AMENDMENT UNDER 37 C.F.R. § 1.111
Application No.: 09/732,712
Atty Docket No.: Q57601

REMARKS

AMENDMENTS TO THE DRAWINGS

Fig. 1

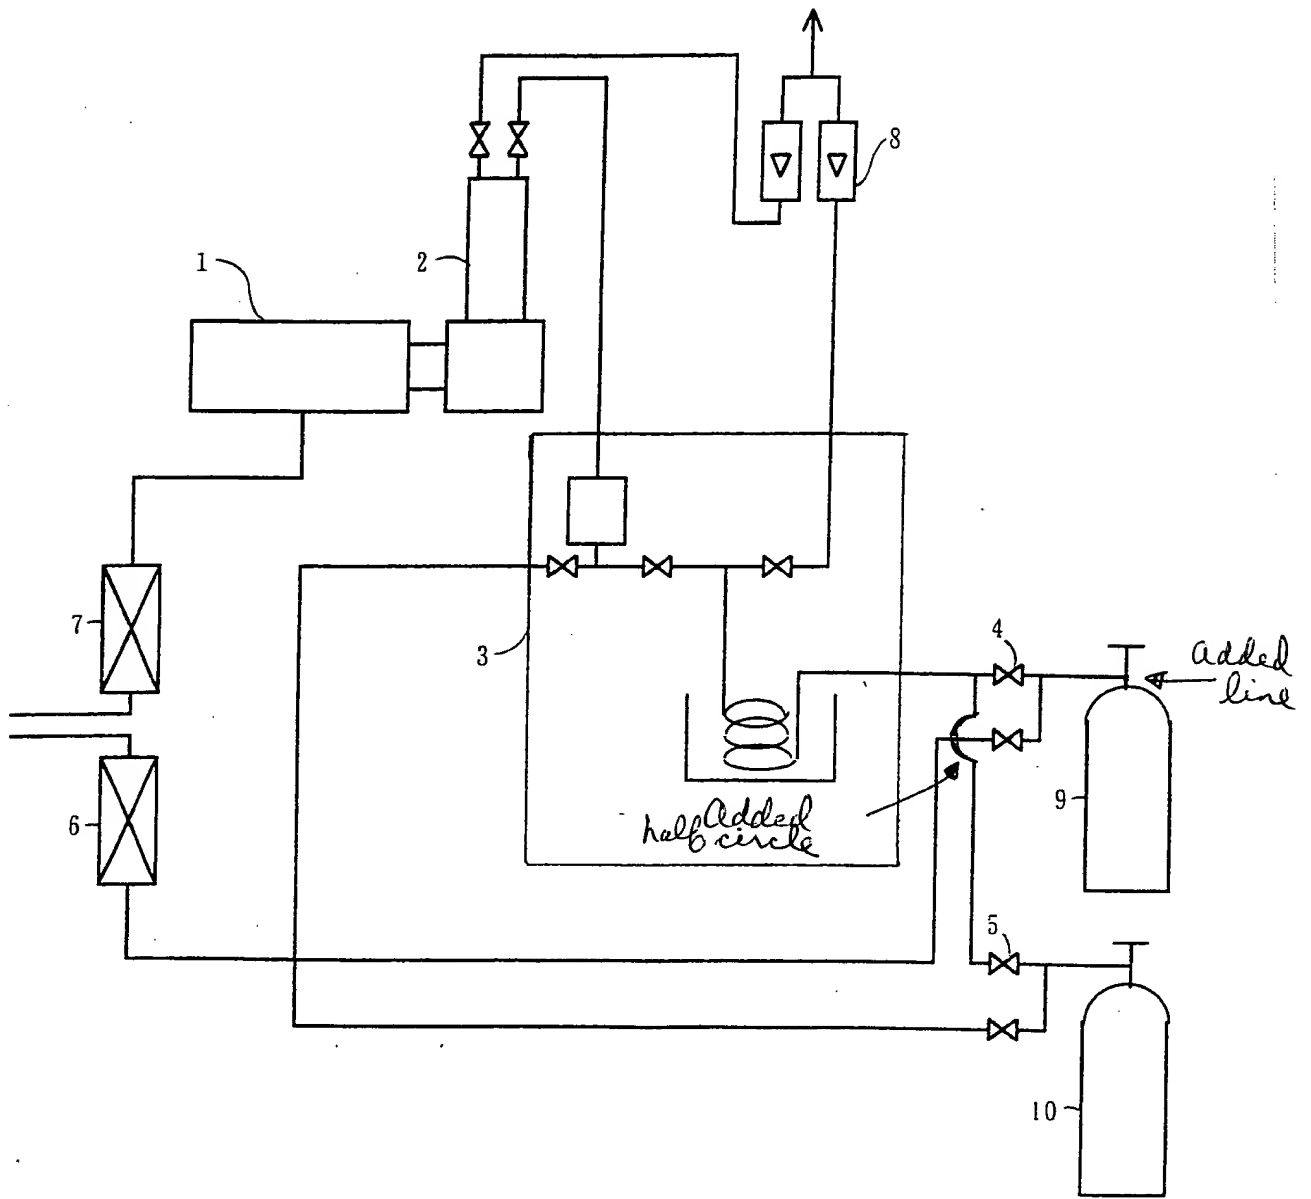
First, the Examiner is arguing that the drawings do not clearly show an apparatus in which liquefied ammonia is withdrawn from the measurement sample cylinder 9, and only show an apparatus in which a gaseous phase moiety of liquefied ammonia is withdrawn from the measurement sample cylinder 9.

The Examiner states that to differentiate between the liquefied ammonia and the gaseous phase moiety of the liquefied ammonia, a pipe, which is inserted in the liquefied ammonia in the tank (measurement sample cylinder 9) and used to withdraw the liquefied ammonia from the tank to the heater, should be shown in Fig. 1. The Examiner states that otherwise, Fig. 1 shows

two identical tanks with pipes for withdrawing gaseous phase moiety of the liquefied ammonia, with one of the pipes being heated.

Applicants note that in Fig. 1, there is a space between connecting line 4 and measurement cylinder 9 at the point where these two members attach to each other. This space should not exist and it was the intention that connecting line 4 is attached to cylinder 9 in the same way as shown for connecting line 5 being attached to reference gas cylinder 10. Applicants enclose a replacement sheet of drawings to correct Figure 1 on this point, as well as an annotated sheet of drawings showing the correction in red.

Further, in Fig. 1, connecting line 5 contains a vertical portion where it connects to connecting line 4. The drawing, however, shows a gap in this vertical portion. This gap was not intended. Applicants have drawn a half circle to connect these lines as a correction, and show this correction in red on the annotated sheet.

With respect to the first reason for the Examiner's objections to the drawings and Fig. 1, applicants submit that the present Fig. 1 would be understood by one of ordinary skill in the art to be sufficient to illustrate a process in which liquefied ammonia is withdrawn from measurement sample cylinder 9 and introduced into the vaporization unit 3.

The measurement sample gas container 9 may have any structure as far as liquefied ammonia can be taken out from the container. Such structures are well known in the art. Applicants enclose herewith a sketch of new proposed Figure 5 which illustrates an example of such a well known structure. Fig. 5 illustrates the inside of the container 9. In Fig. 5, the dipping tube 50 of the container enables liquefied ammonia to be withdrawn from the interior of the container. Upon approval of Fig. 5, applicants will amend the specification as follows:

Please replace Figure 1 with the amended Figure 1 shown in the attached replacement sheet. The amendments to Figure 1 are explained in the Remarks.
